PROJECT NAME: SIte plan for 2620 Sunset Ridge Drive

approval of an Amended Site Plan for a Restaurant on a 2.893-acre parcel of land identified as Lot 2, Block B, Harbor District Addition, City of Rockwall, Rockwall County, Texas, zoned Planned Development District 32 (PD-32), situated within the IH-30 Overlay (IH-30 OV) District, generally located at the southwest corner of the intersection of Sunset Ridge Drive and the IH-30

CASE NUMBER: SP2023-026; Amended Site Plan for 2620 Sunset Ridge Drive

SUBJECT: SP2023-026; Amended Site Plan for 2620 Sunset Ridge Drive

SITE PLAN

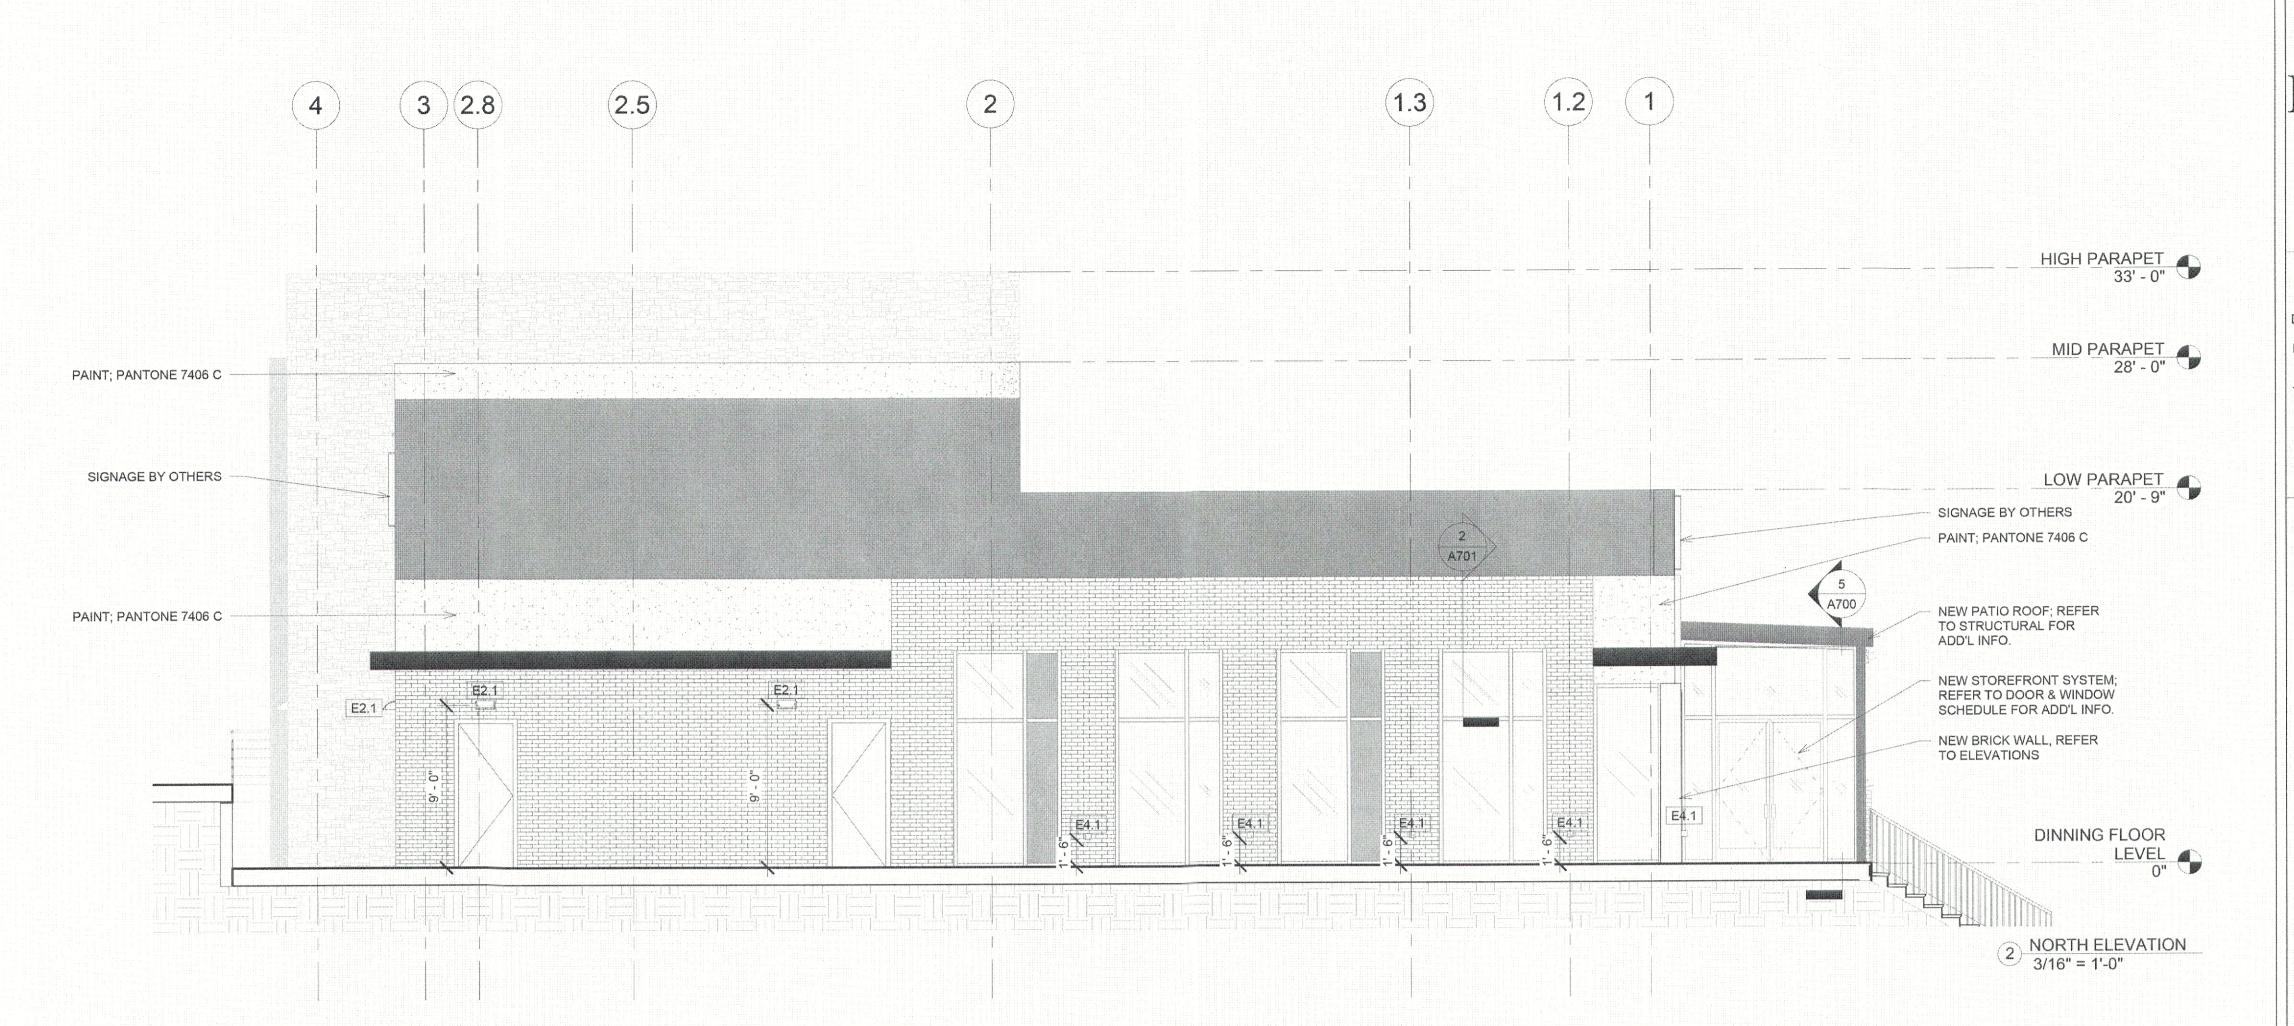
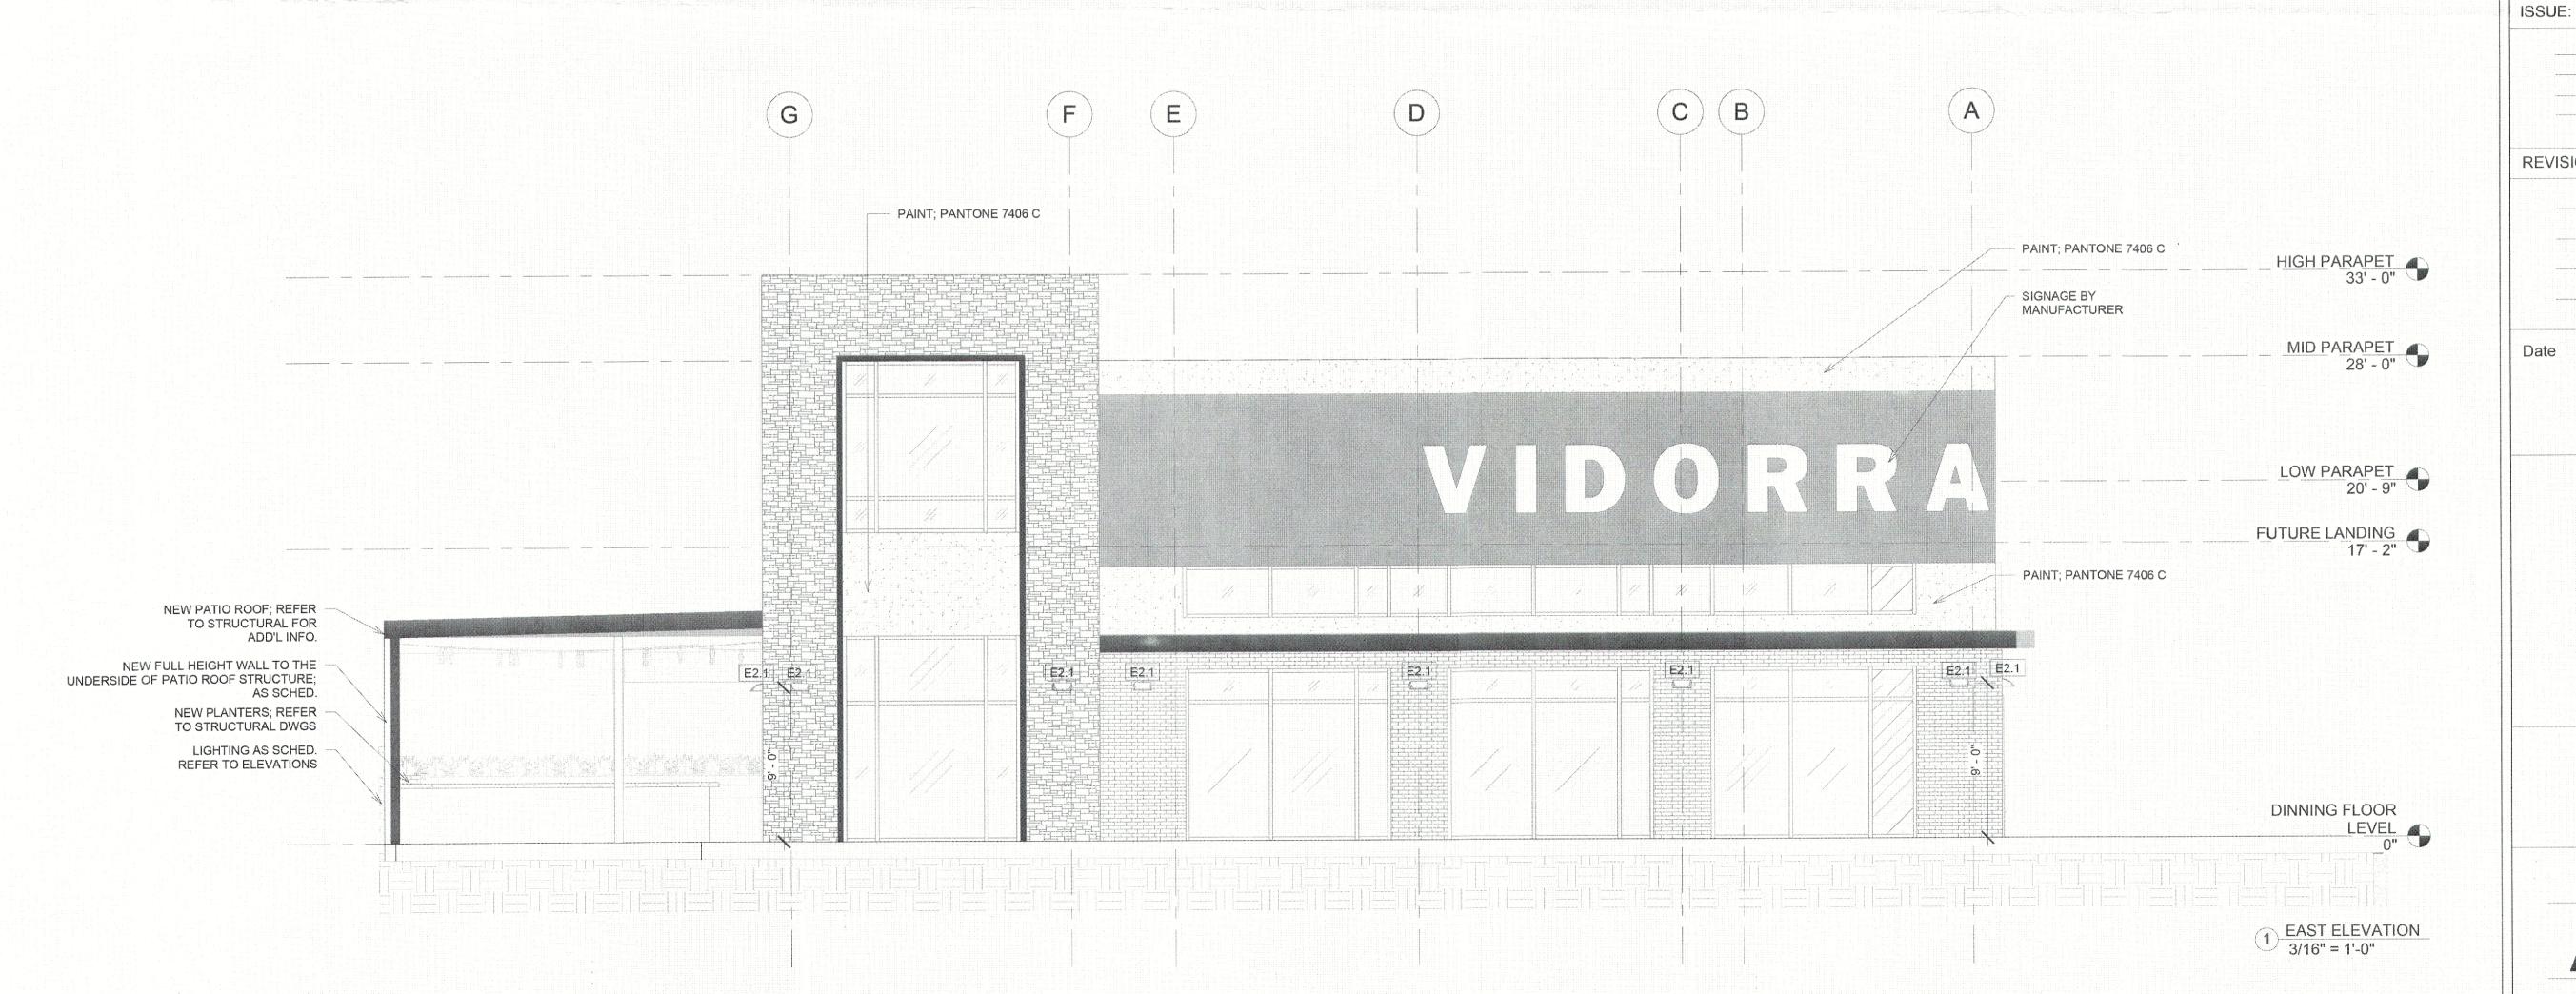
M.6 Site Plan:

(1) A fully developed site plan is required for this amended site plan due to [1] the patio was not captured on the original site plan, rather it was added during the Engineering

process, and [2] the increase of the parking deficiency. In additional, have the extent of the plans cover just be the subject property. (Subsection 03.04. A, of Article 11, UDC)

- (2) Please provide the owners name, address, and phone number. They are required to be in the lower right-hand corner left of the title block. (Subsection 03.04. A, of Article 11, UDC)

- (3) Please provided the name, address, and phone number of the person or company that prepared the plans. They are required in the lower righthand corner left of the title block (Subsection 03.04. A, of Article 11, UDC)

- (4) Please provide a north point, numeric and graphic scale, and a vicinity map. (Subsection 03.04. A, of Article 11, UDC)
- (5) Please indicate the total lot area in acreage and square feet. (Subsection 03.04. B, of Article 11, UDC)

- (16) Please indicate the dimensions of a typical parking space. (Subsection 05.03, of Article 06, UDC)
- (17) Please provide a parking table that indicates the total number of required parking spaces by use (Subsection 05.01, of Article 06, UDC)

- (18) Based on the previously approved site plan 199 parking spaces were required by the land uses indicated; however, an exception was granted to allow 161 parking spaces. That being said, the patio is required 1 parking space per 4 seats. In this case, an additional 25 parking spaces are required. This means you would be requesting to increase the non-conformity of the parking through an exception. (Table 5, of Article 06)

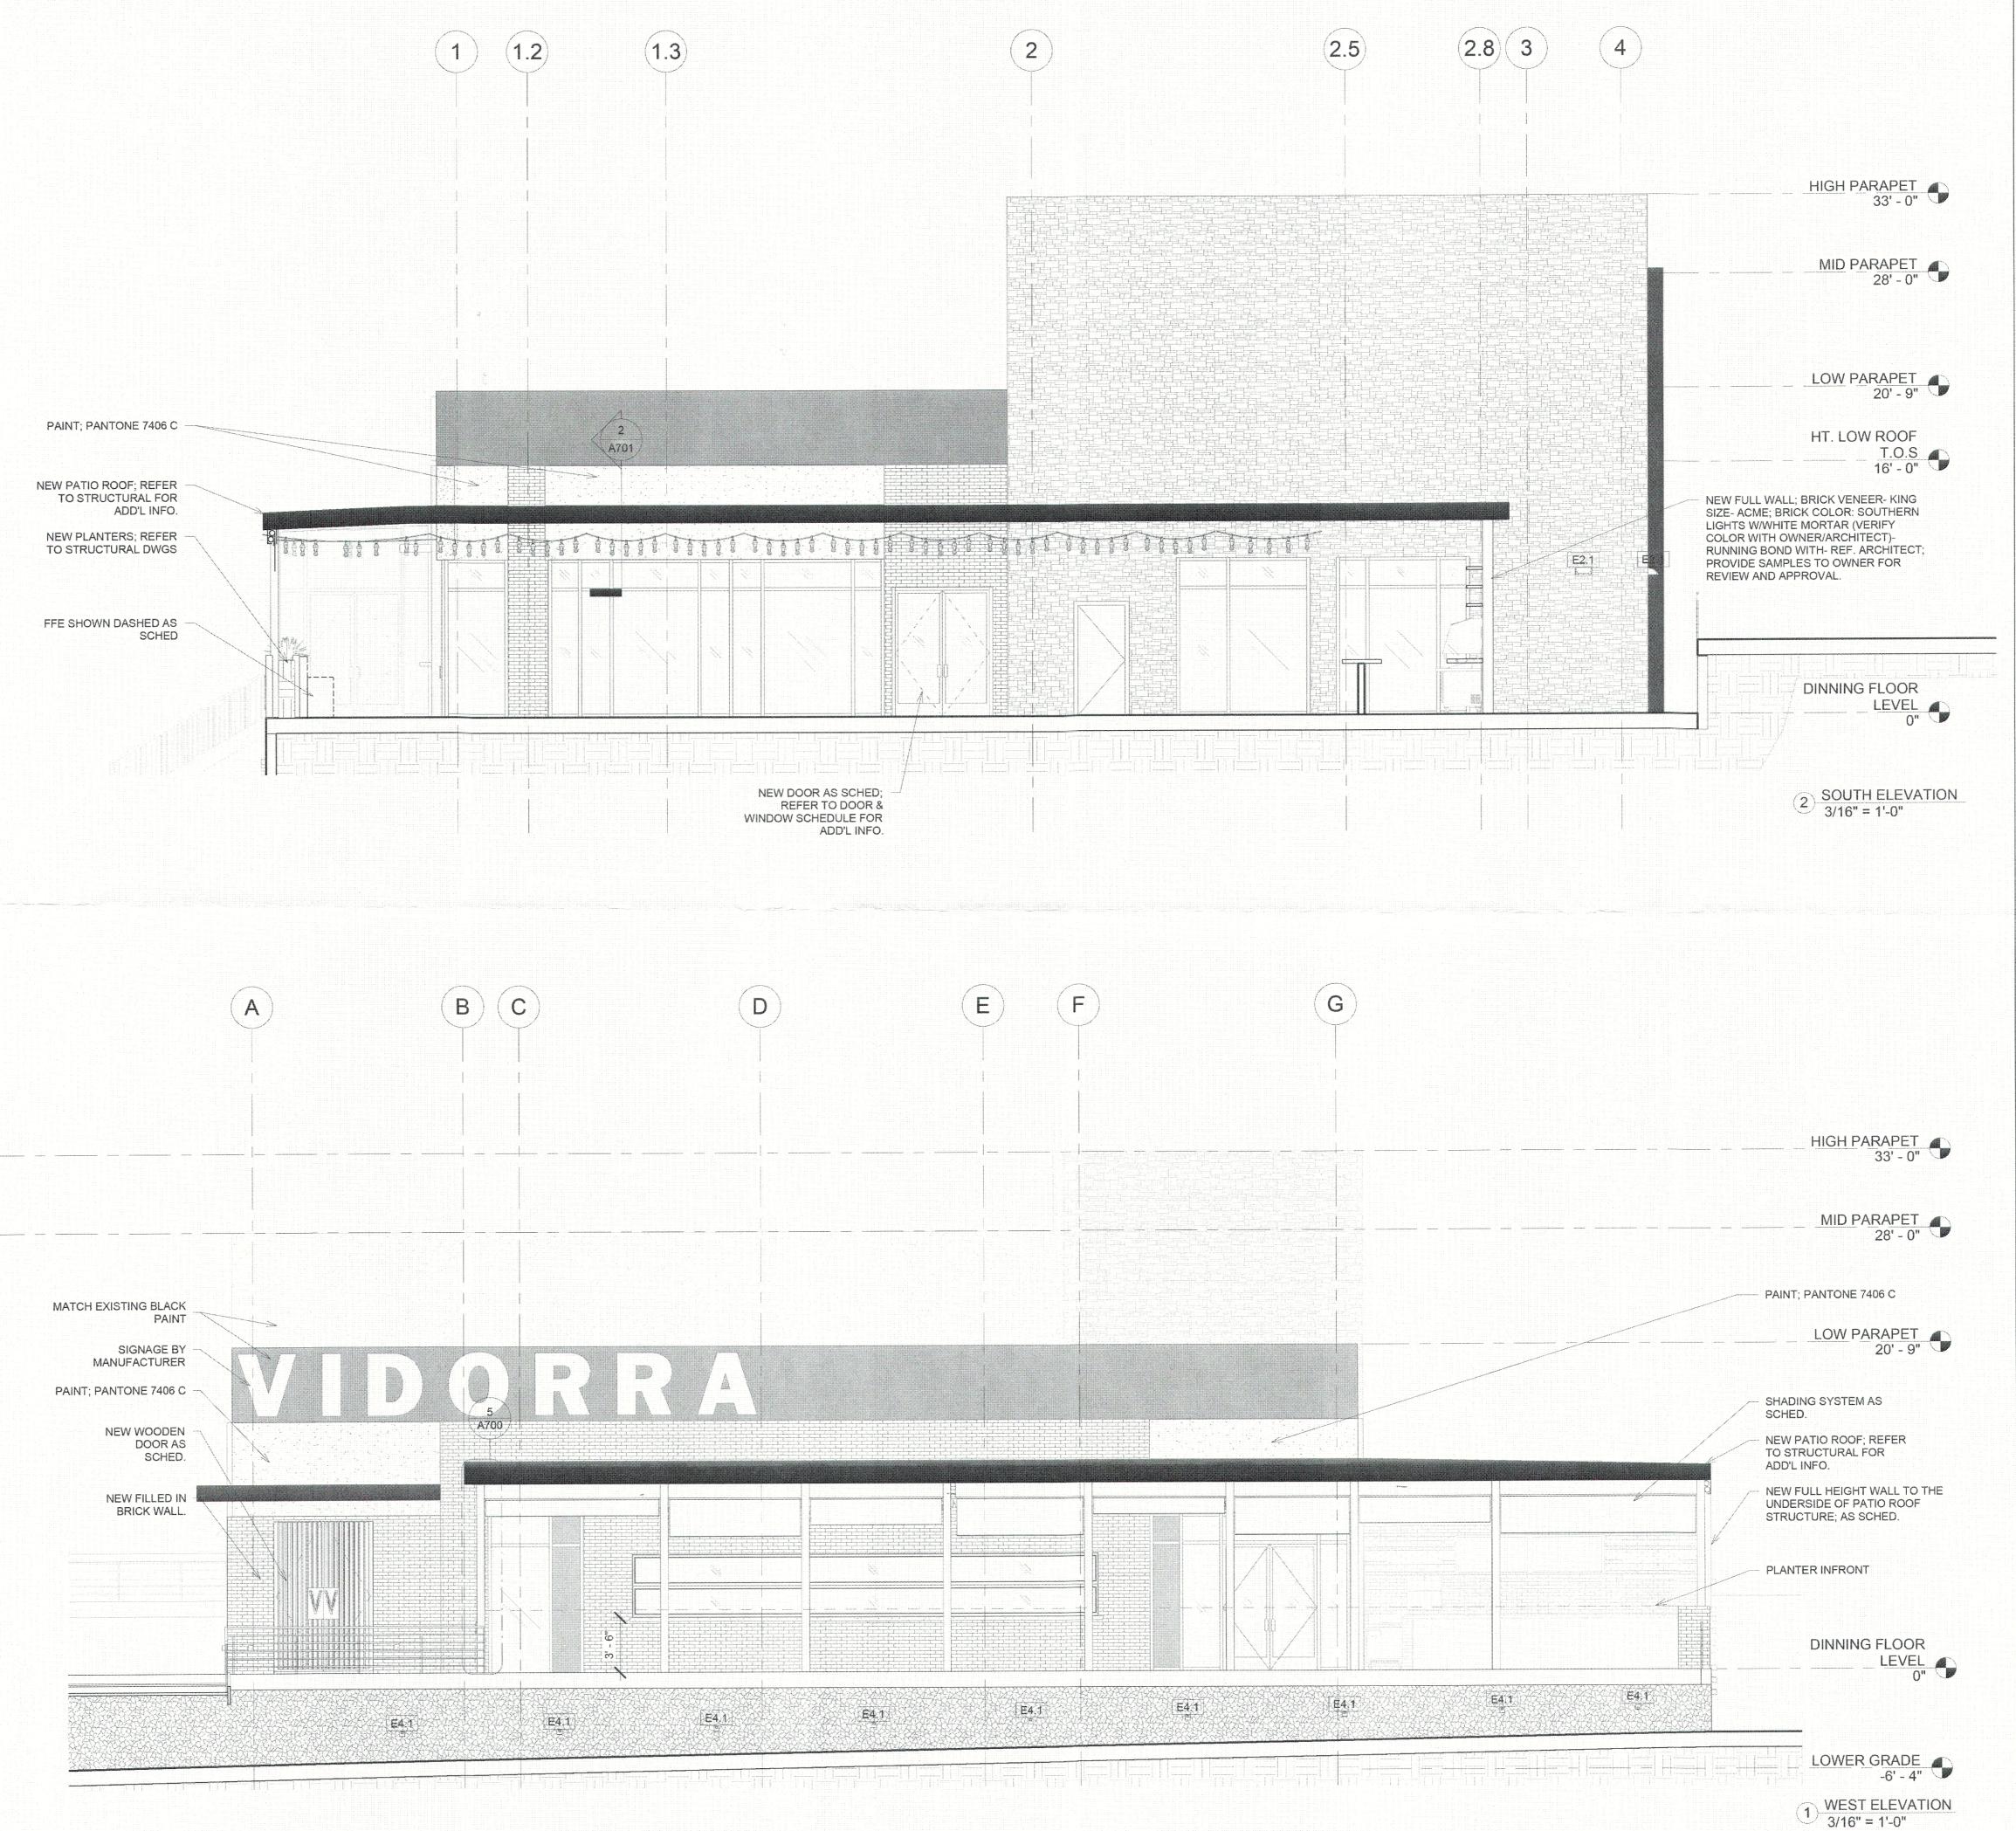
- M.4 Please remove all signage from the building elevation; all signage will be covered by a separate permit. (Subsection 06.02. F, of Article 05, UDC)

- M.7 Building Elevations:
- (1) Please provide spec sheets for all of the proposed materials (i.e. paint colors, roof material, brick, shade system). (Subsection 04.01. C, of Article 05, UDC)
